Amendments to the Drawings:

REMARKS

FIG. 8

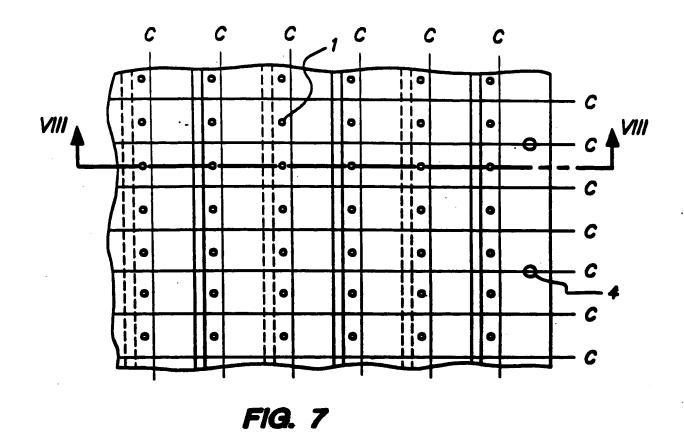
The attached sheet of drawings includes a change to Figure 8. As amended, Figure 8 correctly identifies element 1.

In the drawings, an amendment has been made to Figure 8. As described on page 18, lines 5 to 19 of the specification, Figure 7 is a plan view of an assembly of the invention, and Figure 8 is a cross section on line VII-VII of Figure 7. Element 1 is identified on page 18, lines 13 to 16, as "a tubular cross-conductor 1" lying within an aperture. As shown in Figure 7, a plurality of holes is drilled through the PTC element and the holes are then plated. These holes are marked in Figure 7 as element 1. However, in original Figure 8, element 1 incorrectly identifies plating on the second laminar conductive member 5. As shown in red ink on replacement Figure 8, element 1 should identify tubular cross-conductor running through the thickness of the PTC element 7 from first laminar member 3 to second laminar member 5.
